## 2018 Regional SO<sub>2</sub> Emissions and Milestone Report

*Submitted March 2020*

## 2018 Regional SO<sub>2</sub> Emissions and Milestone Report

**Figure C-4: GCC stack test data for 2016-2018**

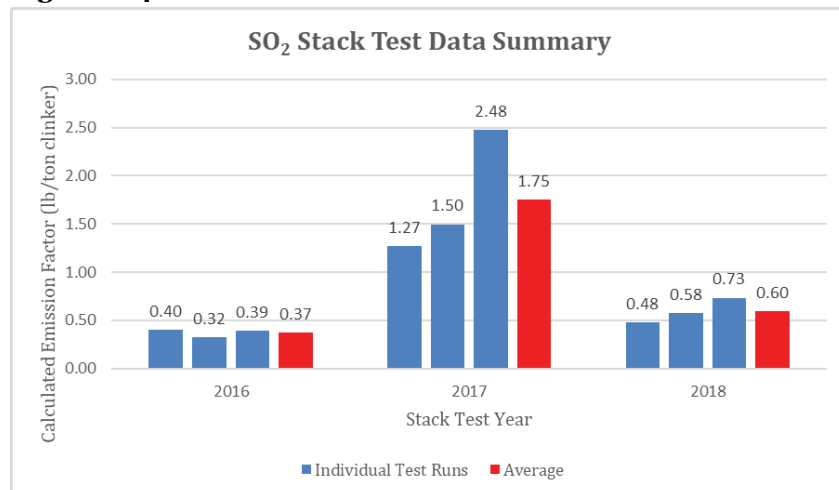
- Comments requested an explanation of (1) the change in emission estimation methods at GCC from 2017 to 2018 and (2) the related changes to the physical makeup of the facility in 2015 (installation of new baghouse and stack).

*Comments requested an explanation of (1) the change in emission estimation methods at GCC from 2017 to 2018 and (2) the related changes to the physical makeup of the facility in 2015 (installation of new baghouse and stack).*

Figure C-4 shows that the emission factor derived from stack testing data varies from test to test and year to year. In light of this variability, it isn't accurate to say that GCC's estimated emissions would have remained constant prior to 2018 if a stack test had been used for emissions inventory reports.

In addition, EHD reiterates that in 2015 and in prior years, conducting stack tests at GCC was physically impossible because no stack existed. GCC could only begin stack testing in late 2016.
